POND HOUSE AT VICTORIA.

FOR MR. & MRS. DAVID BARKER.

ADDENDUM.

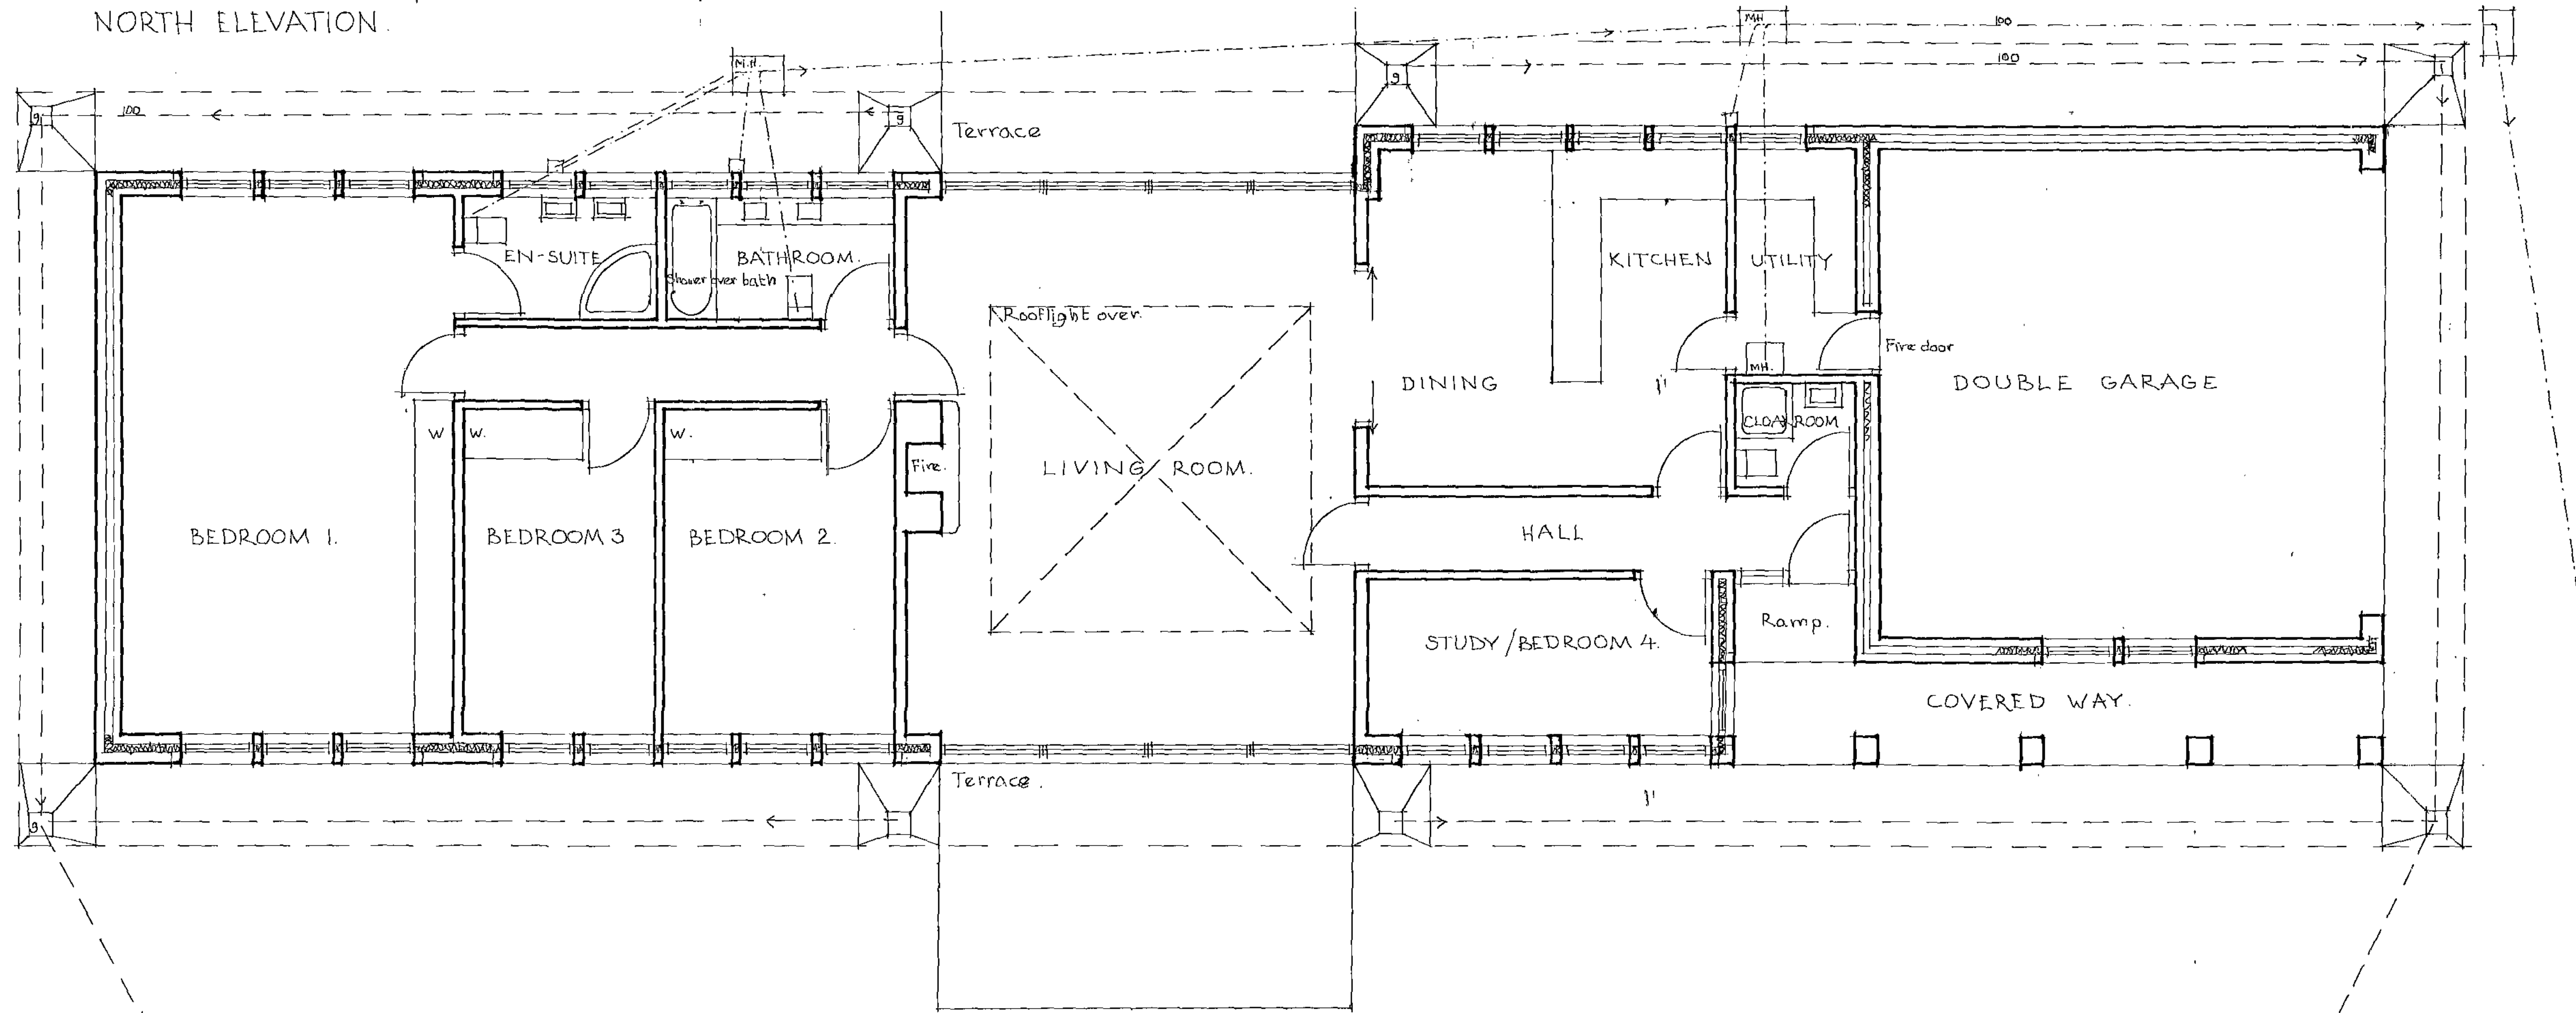
13. Structural details of rooflight to be provided by manufacturer.
14. Structural calculations for 200 R.C. beam to be deposited 28 days prior to these works commencing on site.
